Site: Los Diamantes Subdivision

The following violations were observed at yesterday's inspection:

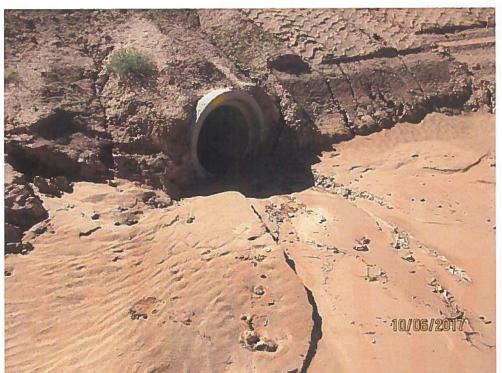
Pond outfall without a sediment BMP. Sediment entered the City's drainage system.

Dirt pile along Blake Rd. No sediment BMP.

- 1. Provide inlet protection for the pond outfall. Protection to be a minimum of 15 inches high. A filter sock pyramid may work the best.
- 2. Remove the dirt pile in the gutter of Blake Rd and provide a sediment BMP in this location to prevent sediment from leaving the site as well as a BMP for the area where the gutter has been removed.

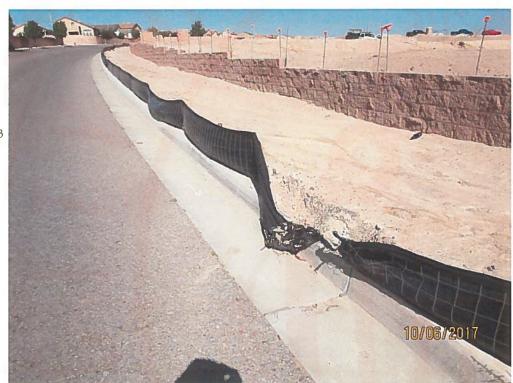
Site exit without a track-out pad. Silt fence missing.

Wash-out draining into pond that outfalls to City's drainage system.

- 3. Prevent vehicles from exiting the site onto Blake Rd or provide a track-out pad.
- 4. Remove wash-out from the pond and other locations. Provide a wash-out facility for wall builders close to work areas. An Outpak may work the best as the work areas move.

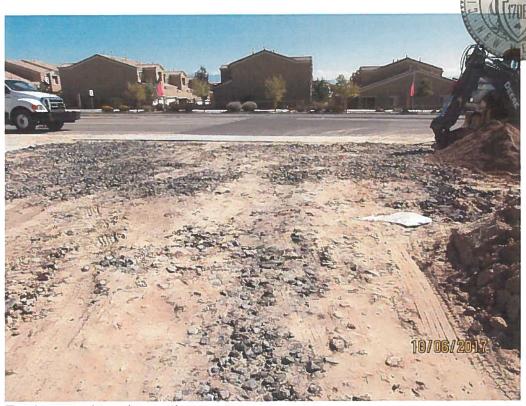
Silt fence requires maintenance.

Track-out pad requires maintenance.

- 5. Maintain the track-out pad.
- 6. Remove sediment from 98<sup>th</sup> St. from the entrance area on 98<sup>th</sup> St. to approximately 100 feet south of Blake Rd.

- 7. Remove sediment from Blake Rd near the dirt pile.
- 8. Maintain the silt fence on Blake Rd.
- 9. Maintain the inlet protection in Blake Rd and Gibson Blvd.

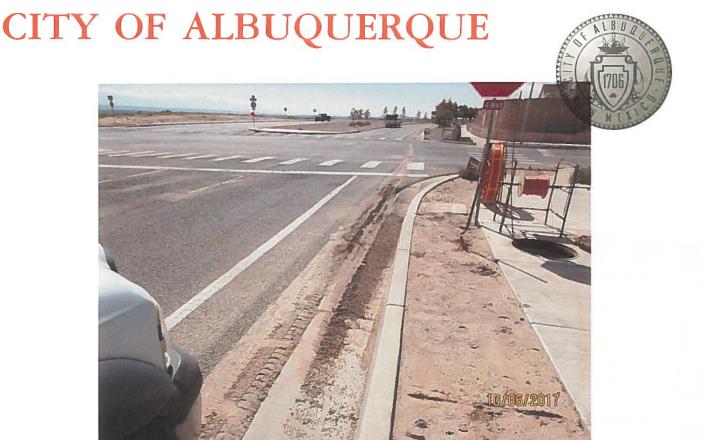
Inlet protection requires maintenance.

Sediment in 98th St.
